# PLAN COMMISSION

Wednesday, June 14, 2023 at 6:30 PM

From: Administrator/Staff  
To: Plan Commission  
Re: Plan Commission review & recommendation on a Site Plan Review Application and Conditional Use Application submitted by Robert E Lee & Associates, Inc. on behalf of PRE/3, LLC for a proposed multi-family housing development consisting of six (6) 12-unit multi-family buildings located on Eagle Heights Dr, specifically described as Tax ID #006-0328-02-02.

SITE PLAN

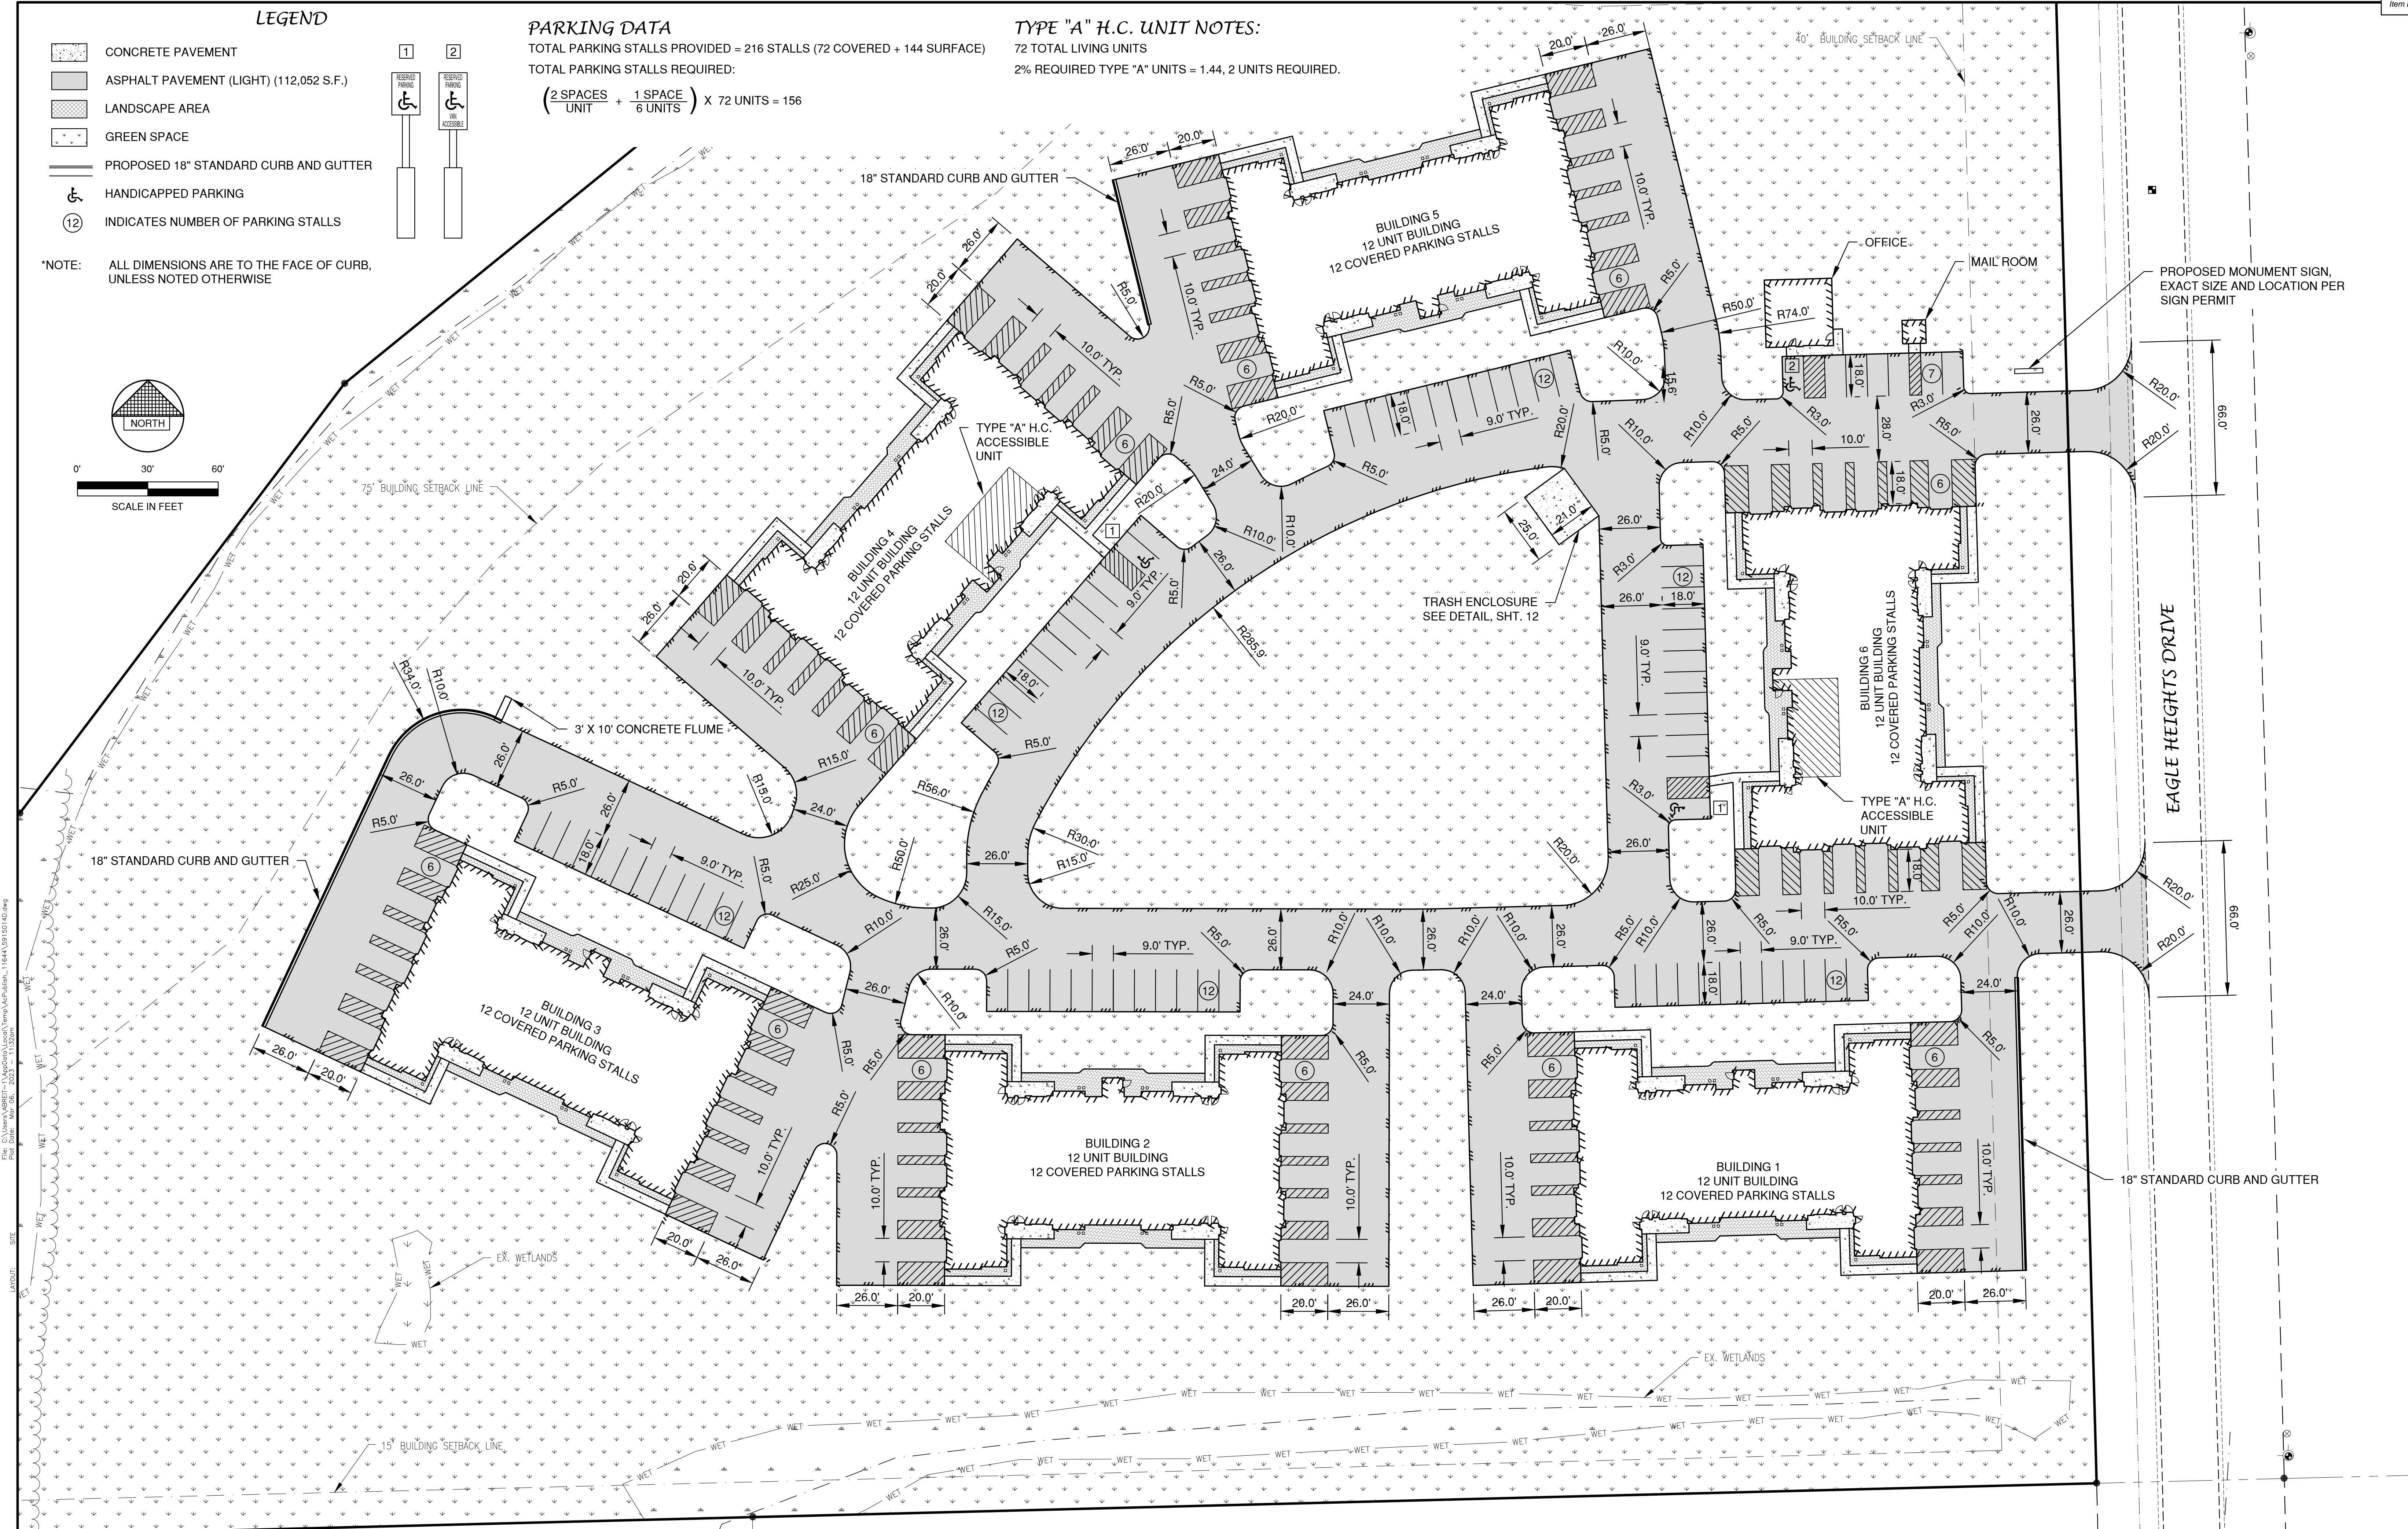
The 25 ft. driveway vision clearance triangle per Sec. A. (2) (b) 1) is not shown on the site plan and the proposed monument sign is located within the 25 ft. vision clearance triangle of the northern driveway. **The vision clearance triangles shall be shown on the site plan, and the monument sign and landscaping/trees shall be relocated to outside of vision clearance triangles.**

1. Horizontal Site Design Standards (Attachment B):
  - a. Driveway widths at their juncture with the street pavement exceed maximum width requirement.
  - b. Vision clearance triangles adjacent to driveways are not identified on plans, and monument sign and landscaping/trees are shown within vision clearance triangle areas which is not allowed.

3. Driveway widths at their juncture with the street pavement shall be reduced to a maximum of 36 ft., as required per Attachment B of the Town Zoning Ordinance. Revised site plan(s) showing this revision shall be submitted to the Town for staff-level review/approval prior to commencing construction.

4. Vision clearance triangles as required per Attachment B of the Town Zoning Ordinance shall be added to the site plan. Any structure(s), sign and/or landscaping exceeding 3 ft. in height above the centerline of Eagle Heights Dr. shall be relocated to outside the vision clearance triangle. Revised site plan(s) showing this revision shall be submitted to the Town for staff-level review/approval prior to commencing construction.

SIGN DETAIL

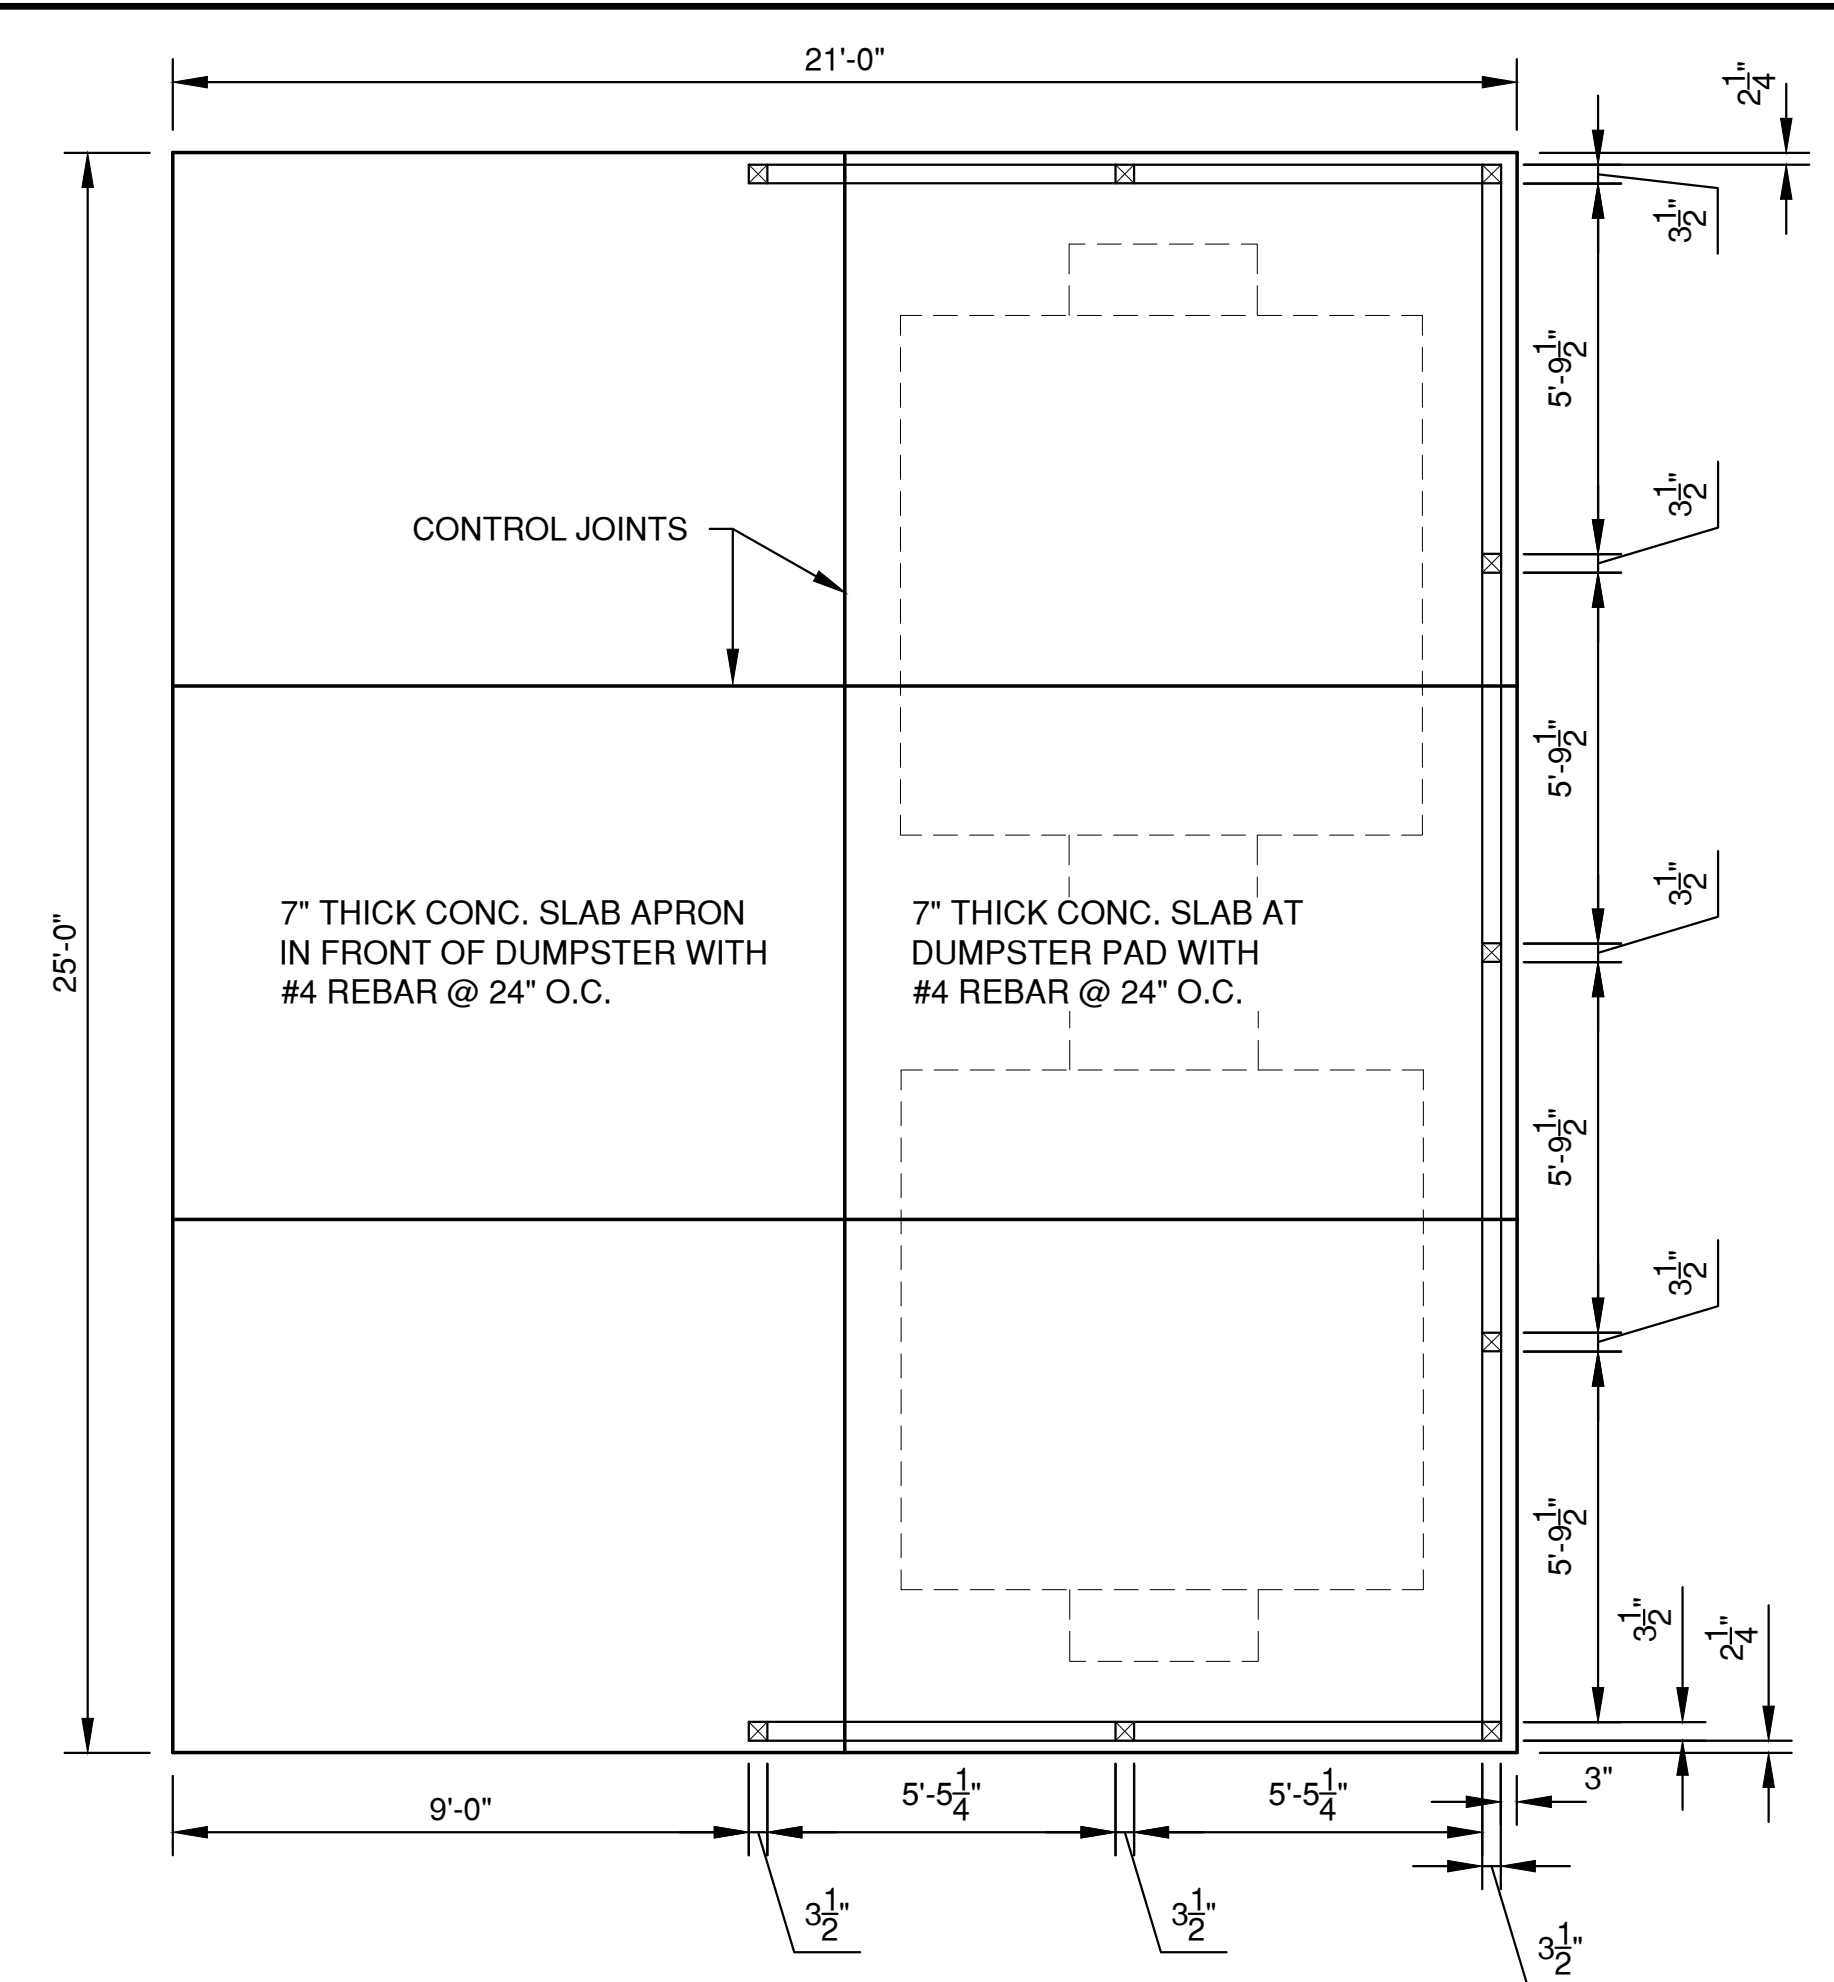
**A sign plan was not submitted, but a ground sign landscaping plan was included in the Landscape Plan which appears will comply with this requirement.**

**A sign lighting plan was not submitted. This requirement is included in the suggested conditions section of this memo.**
